WATER PERMIT NO. 7139-3

**RECOMMENDATION OF CHIEF ENGINEER FOR WATER PERMIT
APPLICATION NO. 7139-3 D & R Ogren**

REPORT ON
WATER PERMIT APPLICATION NO. 7139-3
D & R Ogren
June 8, 2009

June 10, 2009

CORRUGATED METAL PIPE
DROP INLET PRINCIPAL SPILLWAY

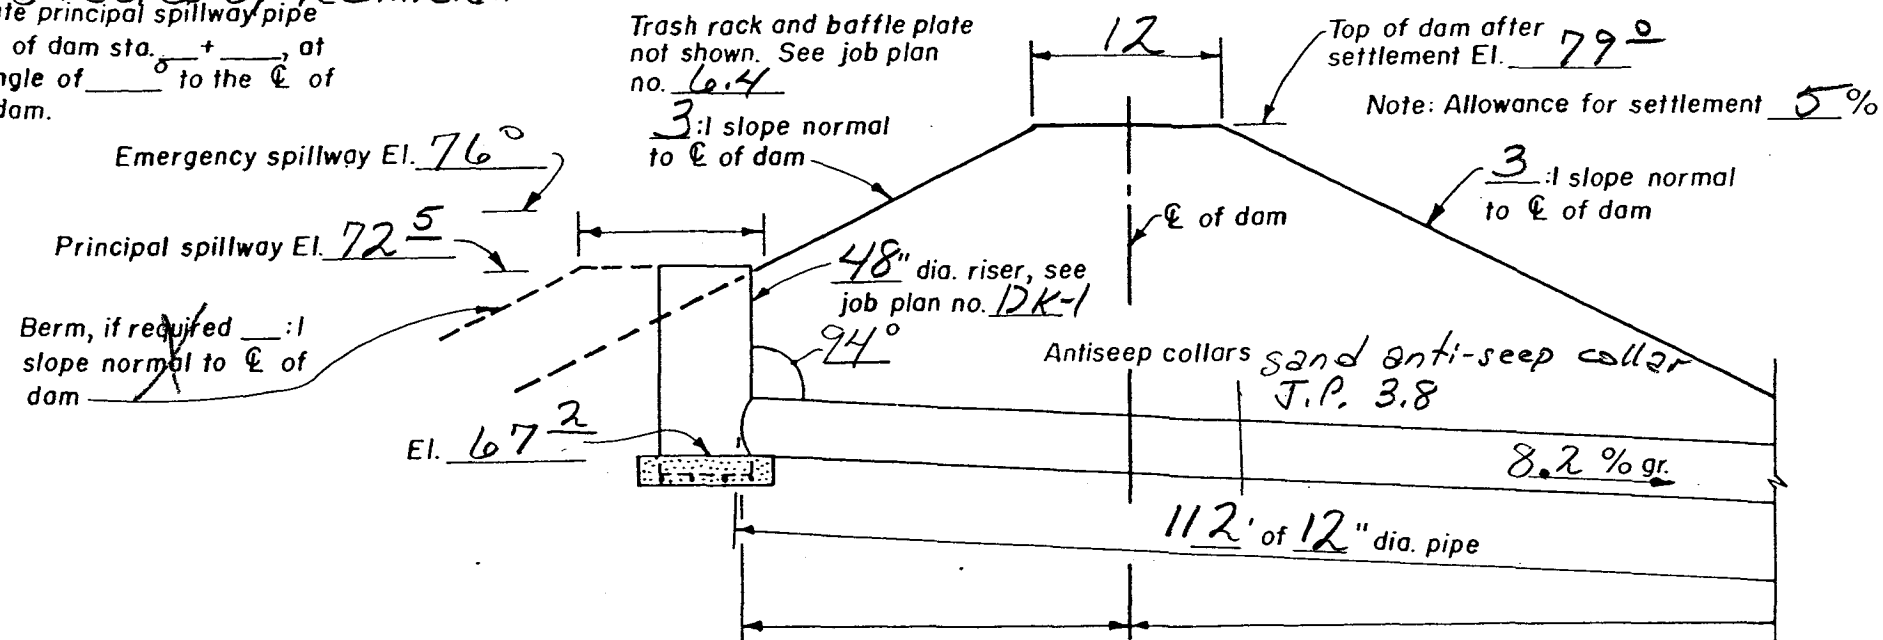
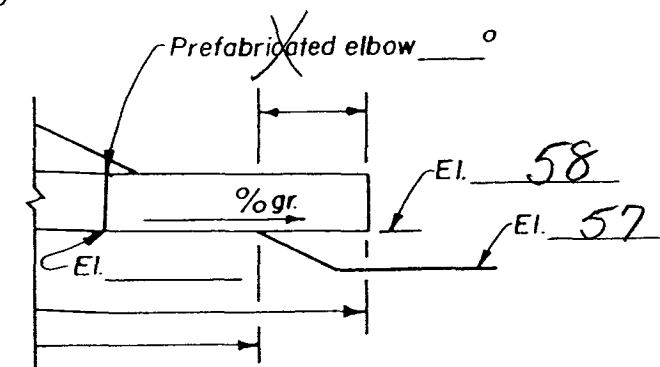
Today, Dave Konechne gave me another set of P&S for the Ogren Dam authorized under Water Permit No. 7139-3. He changed the primary spillway drop inlet structure so it will now have a 48 inch diameter concrete riser with a 12 inch diameter PVC barrel with no change in inlet elevation. I told him I would file doc. this info. and no other P&S approval will be necessary.

CONCRETE RISER
for ~~Reinforced~~ Pipe PVC

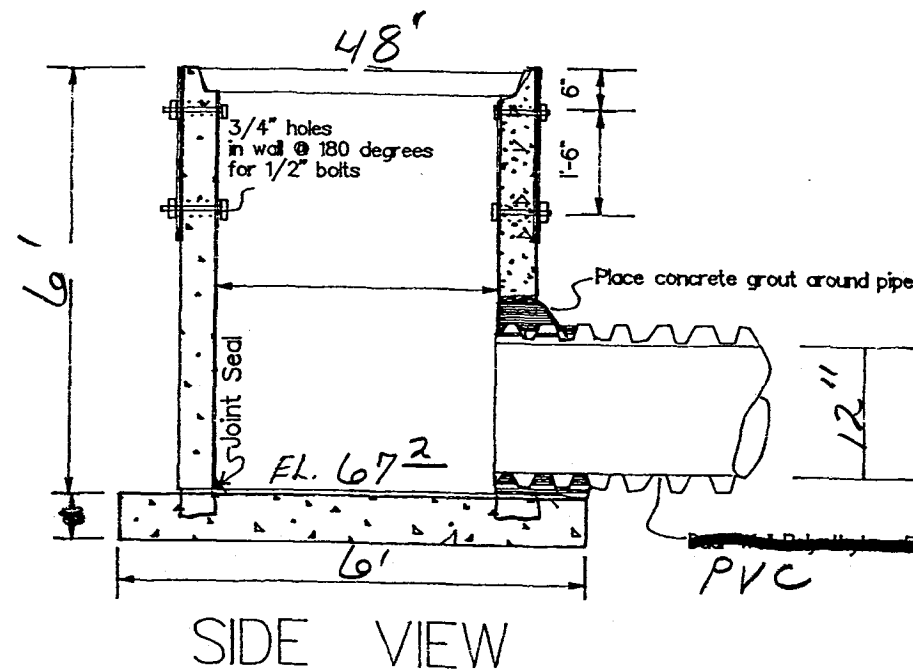
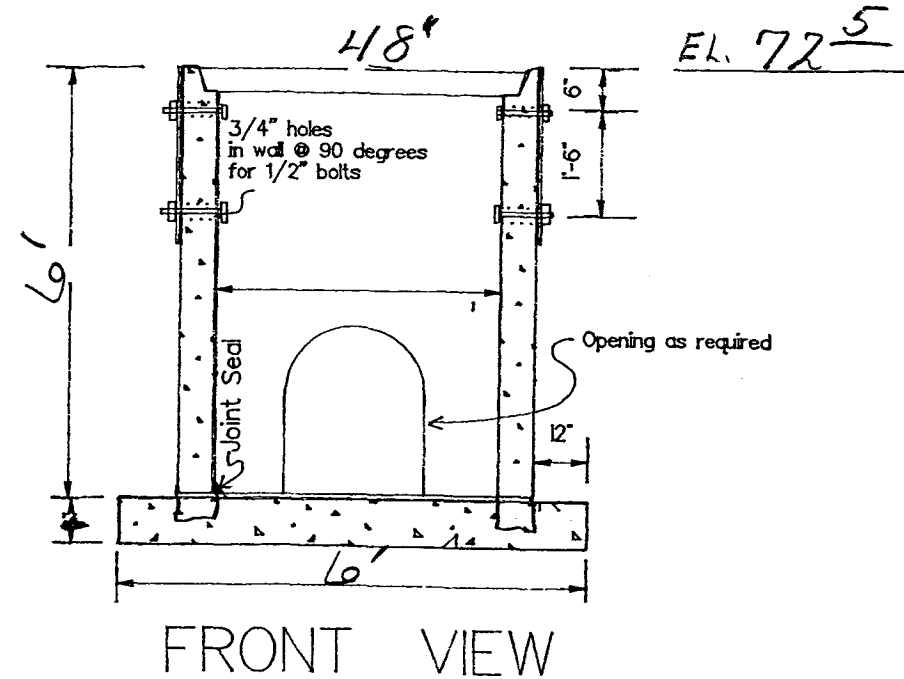
- 1- Reinforced concrete pipe shall meet ASTM C-478.
- 2- ~~Reinforced concrete pipe shall be equal to~~ *PVC - SDR-35 or SDR-26*
- 3- Provide holes in concrete pipe for lifting lugs.
- 4- Alternative to concrete base is poured in place concrete base
